SUBJECT: RESULTS OF INITIAL SCREENING OF GENERIC ISSUE 194,  
"IMPLICATIONS OF UPDATED PROBABILISTIC SEISMIC HAZARD  
ESTIMATES"

PANEL REPORT ON INITIAL SCREENING OF  
GI-194, "IMPLICATIONS OF UPDATED PROBABILISTIC SEISMIC HAZARD ESTIMATES"

ANALYSIS OF  
GI-194, "IMPLICATIONS OF UPDATED PROBABILISTIC SEISMIC HAZARD ESTIMATES"

WATTS BAR SSE and IPEEE SPECTRA vs. TIP (2002)

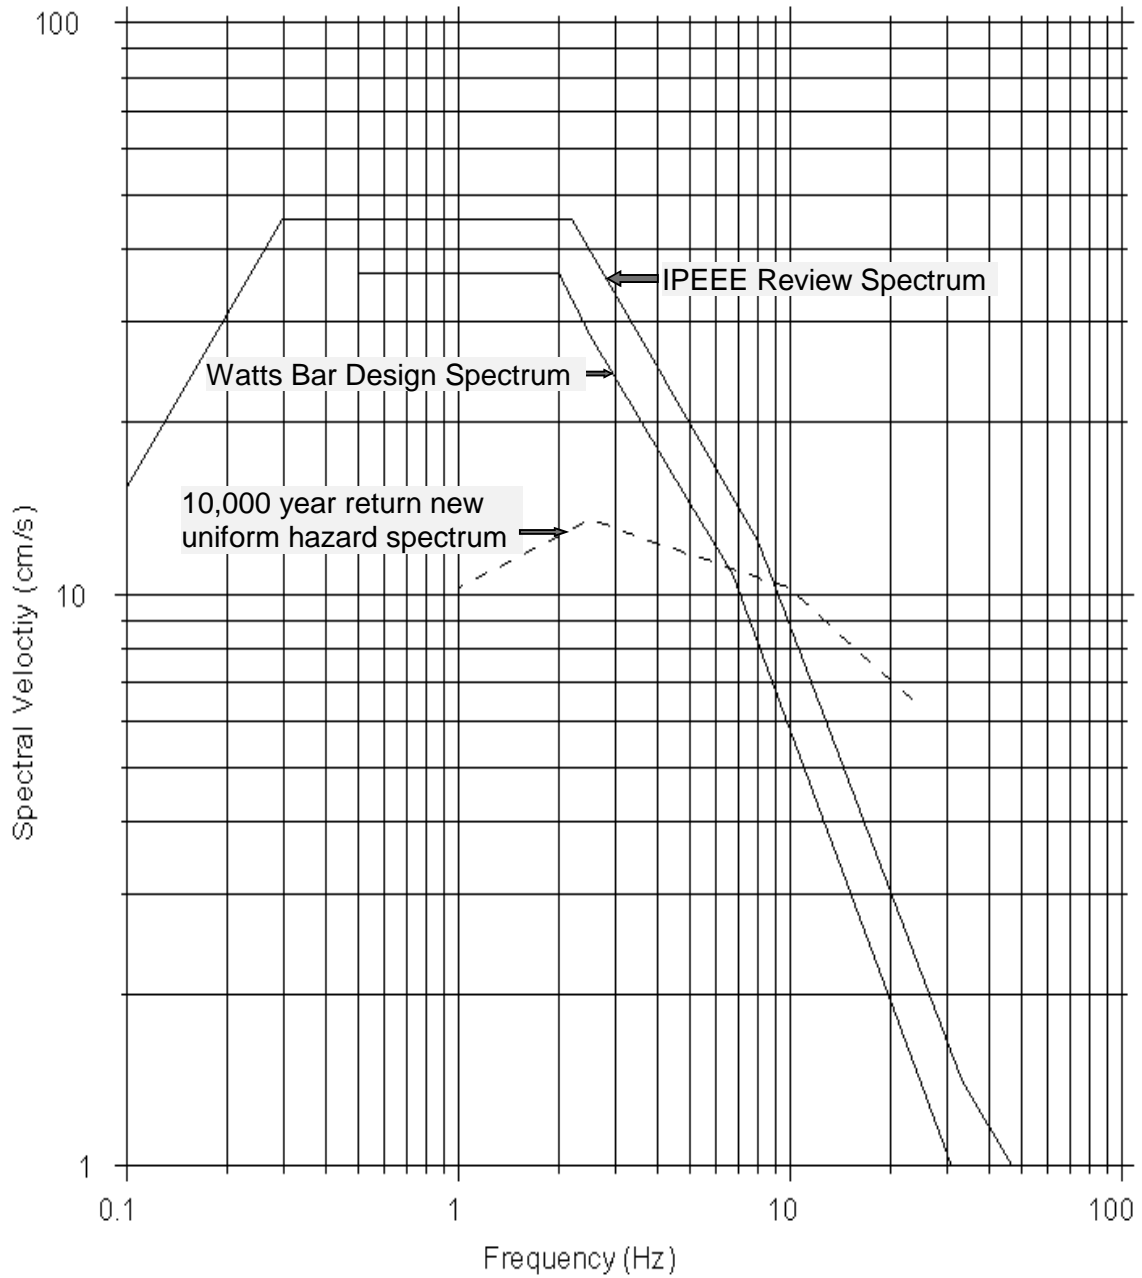
DET/RES conducted a review of the results from the second draft report and plotted its findings which showed: (1) the Watts Bar design response spectrum anchored at 0.18g; (2) the IPEEE spectrum used for the Watts Bar study anchored at 0.30g; and (3) a uniform hazard spectrum calculated using the new hazard results at a mean return period of 10,000 years, which corresponds to a mean reference probability of  $10^{-4}$  (See Figure 1). A comparison of the three spectra showed that the new hazard results were enveloped by: (1) the Watts Bar design response spectrum, below about 7 Hz; and (2) the IPEEE spectrum, below about 9 to 10 Hz. Since the natural frequency range for most structures and equipment in nuclear power plants falls below 10 Hz, it is expected that the new hazard results will have a minimal effect on major structures, systems, and components at Watts Bar. High frequency ground motion above 10 Hz generally affects only active components, such as contacts and relays, which are subject to chatter. Relays and components with high frequency sensitivity have been explicitly addressed in IPEEE evaluations.

The panel discussed at length the basis for the IPEEE guidance on dealing with the high frequency issue and compared various ground motion spectra, including the latest models of NUREG/CR-6728<sup>2</sup> for the eastern United States. During the IPEEE guidance development, the issue of high frequency was explicitly addressed. As discussed above, the high frequency motion affects components, such as relays, and brittle components, e.g., potentially some anchorage. Based on tests conducted by NRC and the industry, a list of relays with known vulnerability was developed. During the IPEEE process, the plants were specifically addressing these relays. When identified, these relays were either replaced or shown not to have an adverse impact. The industry had also conducted tests to address the anchorage issue. Comparison of the ground motion results by NRC (NUREG-1488<sup>3</sup>) and EPRI,<sup>4</sup> and new results show differences in the ground motion level, but the frequency characteristics are essentially the same.

**Comparison of the Mean Seismic Hazard Estimates for the Watts Bar Site**

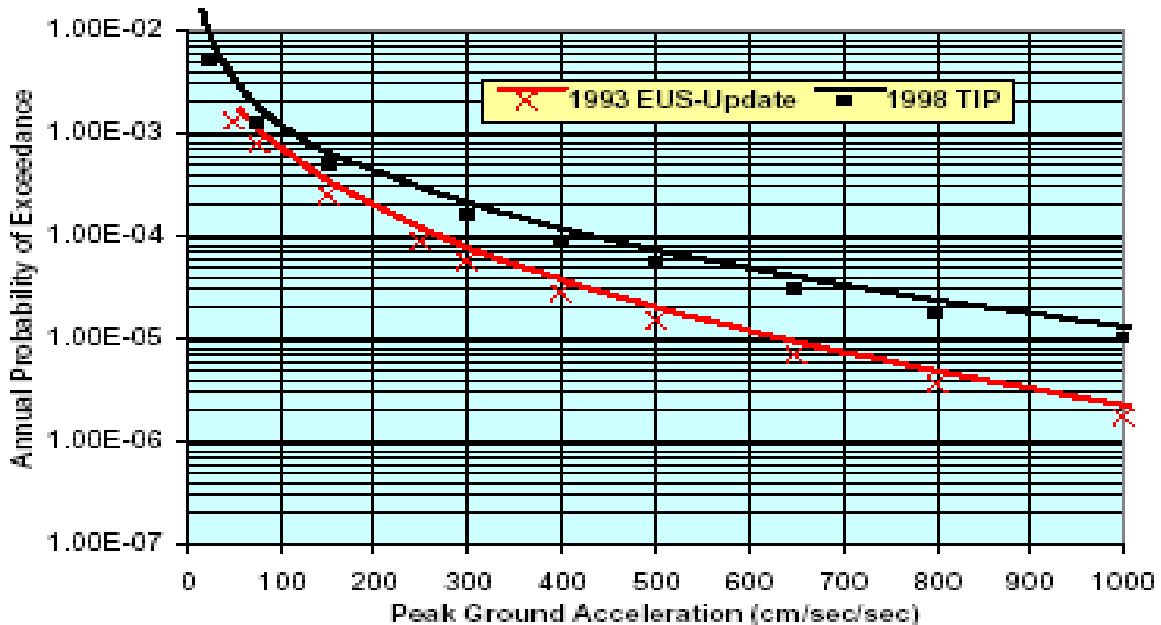
A comparison of the TIP and Reference 3 hazard curves for the peak ground acceleration values is shown in the plot shown below.

At the reference annual frequency of  $10^{-4}$ , the TIP results are about 1.6 times higher than the 1993 EUS-Update estimate. Sites with operating plants in the proximity of the ETSZ are Browns Ferry, Sequoyah and Watts Bar. Based on the results for the Watts Bar site, there is a potential that the ETSZ could influence the seismic hazard at these other sites as well. The effect of changes in ground motion model, although secondary in nature, can increase the response spectrum shape in the high frequency range from 9 Hz to 50 Hz. A recent study<sup>11</sup> also shows the increase of spectral ordinates in the high frequency end. Seismic input in the high frequency end of the response spectrum can cause relay chatter and other effects to vibration-sensitive components. The USGS seismic hazard maps for the Eastern Tennessee area also indicate a higher seismic hazard.

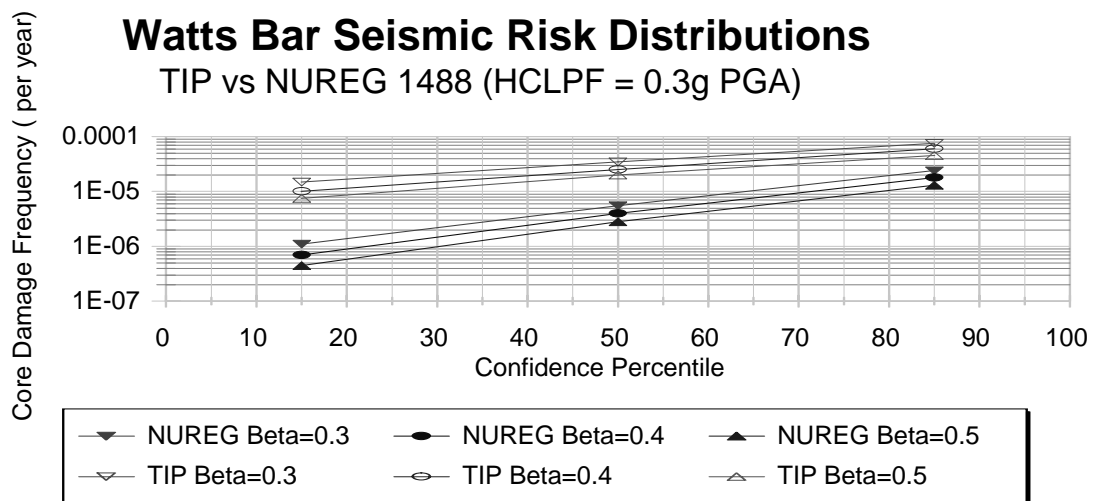
In order to determine the sensitivity of the estimated CDF for the Watts Bar site using the TIP seismic hazard curve, several CDF estimates were made using the mean, 15<sup>th</sup>, and 85<sup>th</sup> percentile hazards, with varying uncertainties (beta values).

From the above figure, it is apparent that the CDF values are not very sensitive to the percentile level of the hazard curve. This is because the HCLPF value is high and at the low end of the annual frequency of occurrence.
